I am providing the comments on the Physical Characterization Technical Memorandum for the West Lake Landfill Operable Unit 2 Birdgeton, Missouri. A number of these comments are editorial in nature and are of little significance, while others are of more concern and should be addressed in a document modification. The comments are organized as the document is written. Each comment will be preceded by the page number and the section number of the location where the specific comment is found. In some instances, only section numbers will be given as the comment is generic to that section. I am aware that you have already received a copy of the State of Missouri's comments, but I have integrated them into this letter as well.

**WEST LAKE
LANDFILL**

**RE MONTHLY PROGRESS REPORT - SEPTEMBER 1996
WEST LAKE (BRIDGETON) LANDFILL
OPERABLE UNIT 2 RI/FS**

**RESPONSE TO THE APRIL 4, 1996 LETTER REGARDING PROJECT SCHEDULE
WEST LAKE LANDFILL RADIOLOGICAL AREAS 1 AND 2
BRIDGETON, MISSOURI**

DRAWN	TMC	DATE	AUGUST 1996	JOB NO	943-2848
CHECKED	CER	SCALE	AS SHOWN	DWG NO / REV NO	A034
REVIEWED	WEH	FILE NO	2848A034	FIGURE NO	3-2

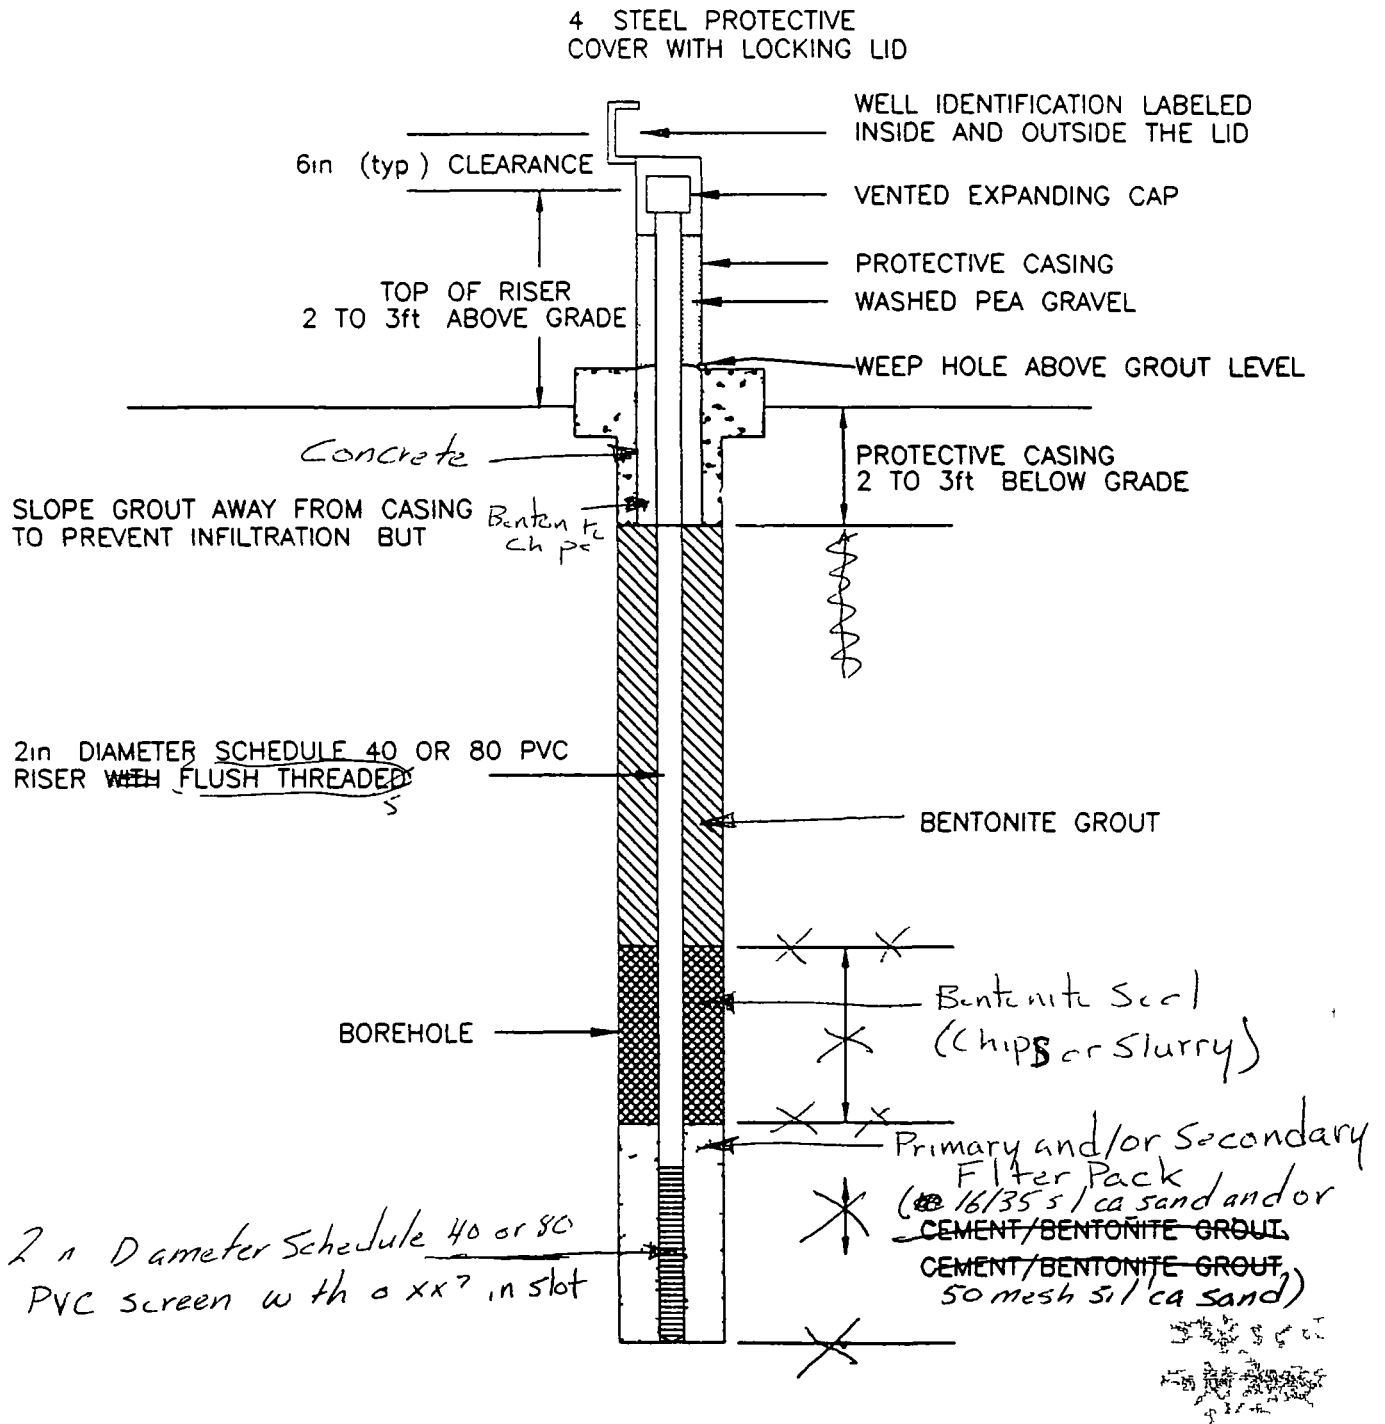
Figure 3-2 - This figure shows that the screened interval of the borehole has been grouted with a cement/bentonite grout My assumption is that this is not the case This is not the only problem with the figure, additional modifications will be necessary to complete the figure I am enclosing a copy of the figure with some suggested modifications These should guide you in redrafting the figure to show what was actually constructed It would be beneficial for a well construction diagram for each well to be used in the monitoring system to be included, or at least a table of elevations for the various elements to provide specific details at to the construction of each well in the monitoring system, and a figure showing a typical long-screened interval Piezometer

3 2 2 1 -General - It is unclear what the annular space above the bentonite seal is backfilled with Figure 3-2 indicates bentonite grout was used, but that figure appears to be unreliable

Figure 3 2 This figure shows that the screened interval of the borehole has been grouted with a cement/bentonite grout. My assumption is that this is not the case. This is not the only problem with the figure, additional modifications will be necessary to complete the figure. I am enclosing a copy of the figure with some suggested modifications. These should guide you in redrafting the figure to show what was actually constructed. It would be beneficial for a well construction diagram for each well to be used in the monitoring system to be included, or at least a table of elevations for the various elements to provide specific details as to the construction of each well in the monitoring system and a figure showing a typical long-screened interval Piezometer.

3 2 2 1 General - It is unclear what the annular space above the bentonite seal is backfilled with. Figure 3-2 indicates bentonite grout was used, but that figure appears to be unreliable.
